# West of Orkney Windfarm Offshore EIA Report Addendum

## Shipping and Navigation Additional Information

**ASSIGNMENT** L100632-S15  
**DOCUMENT** L-100632-S15-A-REPT-005

Document Number	WO1-WOW-PER-ENV-RPT-0009
Revision	01
<b>Approved</b>	
Mr Stuart McAuley - Offshore Wind Power Limited	
Oct 9, 2024, 9:40 PM GMT+1:00

Figure 4-7 Overview of the gaps

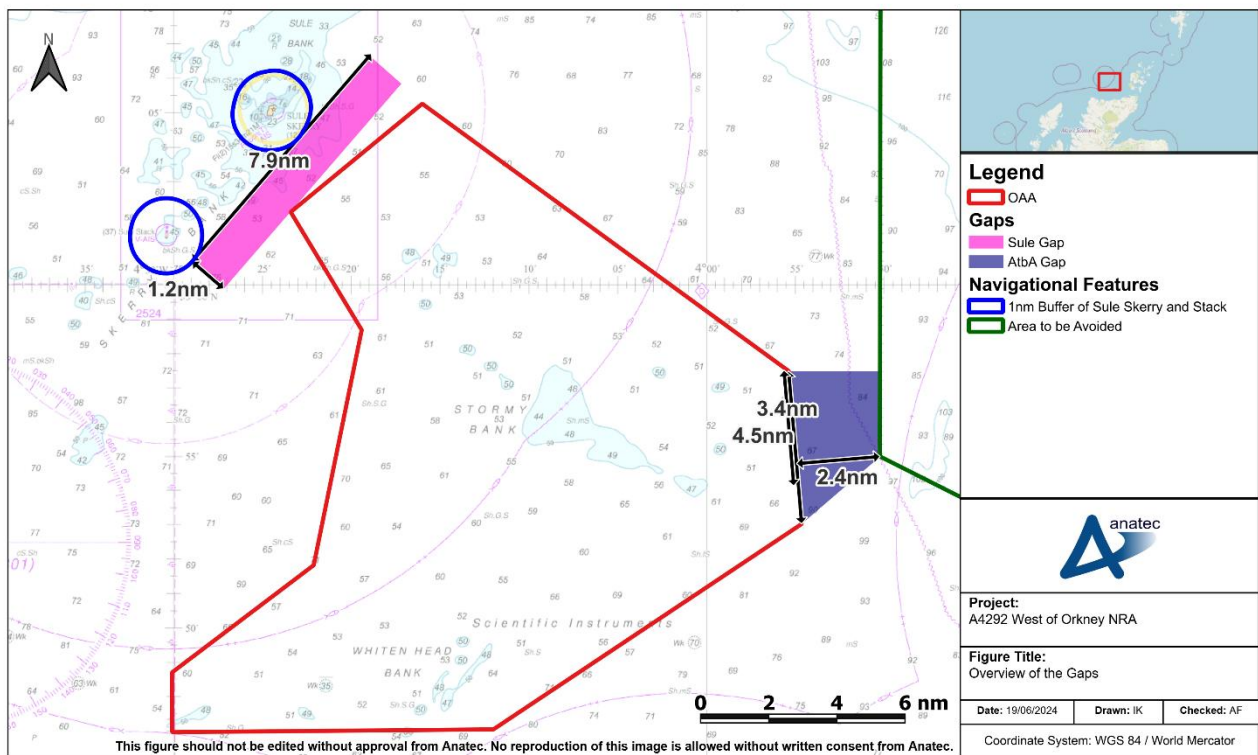
Although the length of the OAA on the Sule gap is approximately 5 nm, Sule Stack, as well as Sule Skerry must also be taken into account as a navigational hazard. From vessel traffic data collated during the NRA process (see Supporting Study 14: Navigational risk assessment of the Offshore EIA Report), it is considered unlikely that a vessel would opt to transit within 1 nm of either the Sule Skerry or Sule Stack given the significant navigational hazard posed. On this basis, for the purposes of the calculations in this report, the Sule gap is considered as being bounded by a 1 nm buffer of Sule Skerry and Sule Stack. The eastern extent is bounded by the northernmost point of the OAA, and

the western edge by the Sule Stack. On this basis the Sule gap has a length of 7.9 nm and minimum width of 1.2 nm (see Figure 4-7).

The ATBA gap is defined as the searoom between the OAA and ATBA, with a length of 4.5 nm and minimum width of 2.4 nm. There is no physical hazard bounding the eastern edge of the ATBA gap, and this has been accounted for in the calculations (further details of this are provided in section 4.4.2).

Figure 4-8 Proposed mitigation

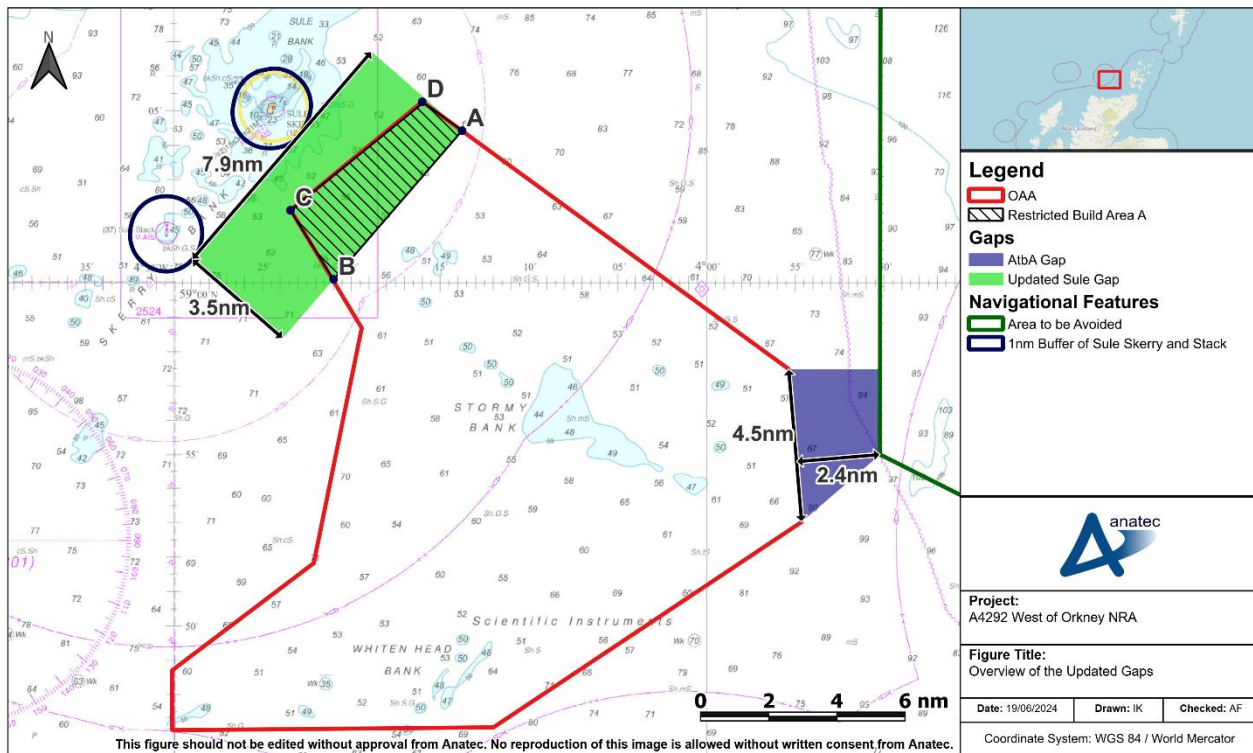
REQUEST	RESPONSE
<p>Both the MCA and the UKCoS raised concerns regarding the proximity of the OAA to Sule Skerry. With regard to the north westerly boundary of the OAA in proximity to Sule Skerry, the UKCoS recommended that for safe navigational purposes, a sufficiently wide channel be introduced for navigation between Sule Skerry and the wind farm for commercial vessels to safely transit through.</p> <p>The UKCoS also raised concerns that the easterly boundary of the OAA, specifically its proximity to the IMO Routeing ATBA creates a chokepoint and navigational risk hotspot. The UKCoS therefore strongly recommends that a viable channel be maintained for a vessel weather routeing in adverse conditions and as such calls for a greater area of sea-room to be maintained.</p> <p>The UKCoS also raised concerns in relation to the hazard log presented in Appendix B of the Offshore EIA Report, Supporting Study 14: Navigational Risk Assessment. UKCoS consider that the risk of "Displacement (adverse weather routing)" is higher than "Tolerable with mitigation". The UKCoS requested further details on the proposed mitigation measures to be developed post-consent, such as a Structures Exclusion Zone (SEZ).</p>	<p>Chapter 15: Shipping and navigation of the Offshore EIA Report and Supporting Study 14: Navigational Risk Assessment considered the navigational safety of the sea space between Sule Skerry and the OAA and between the ATBA and the OAA.</p> <p>Section 4 of this Additional Information presents additional mitigation to address the concerns raised, in the form of minimum navigational corridor widths, to ensure that the sea space is safe to transit through (see section 4).</p> <p>The Applicant is committing that no WTG, offshore substation platform or met-ocean measuring equipment forming part of the offshore Project will be erected within Restricted Build Area (RBA) A (see section 4.4.2). This will be enforced through a proposed condition on the Section 36 consent and/or Marine Licence.</p> <p>The Applicant held teleconferences with the UKCoS (26<sup>th</sup> April 2024) and the MCA (30<sup>th</sup> April 2024) to discuss the proposed Safety Case and the proposed minimum navigation corridor widths.</p>

On the basis of the calculation outputs, and consultation with the MCA and the UKCoS on the proposed mitigation and calculations behind it, it is proposed that:

- The Sule gap is widened to 3.5 nm (4.5 nm in total accounting for the 1 nm buffer referenced in section 4.4.1); and
- The ATBA gap remains at its current width of 2.4 nm (this is based on the outputs of the corridor calculations, the very low frequency of use, and the lack of a physical hazard bounding the eastern edge).

The mitigation will be implemented via RBA-A, which commits to no WTG, offshore substation platform or met-ocean measuring equipment, forming part of the offshore Project, being erected within the green region shown in Figure 4-8.

Figure 5-1 OOA with highlighted RBAs

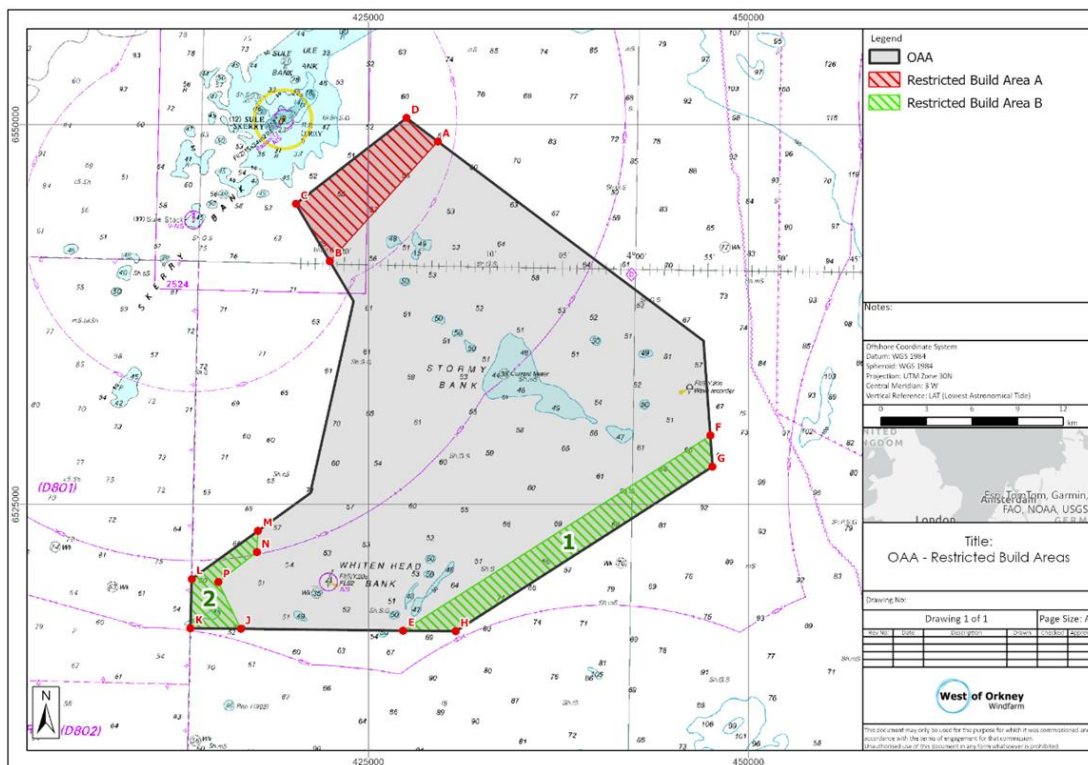
A further RBA, RBA-B, has been developed in relation to seascape, landscape and visual receptors (see [Seascape, Landscape and Visual Additional Information](#) and section 4 of the [Introduction](#) for further information) (see Figure 5-1). While not developed for shipping and navigational concerns, RBA-B has a proposed consent condition as outlined below which required consultation with the MCA:

- No WTG forming part of the Development shall be erected; and
- Unless otherwise agreed in writing by the Scottish Ministers following consultation with the MCA, no offshore substation platform or met-ocean measuring equipment forming part of the Development shall be erected.
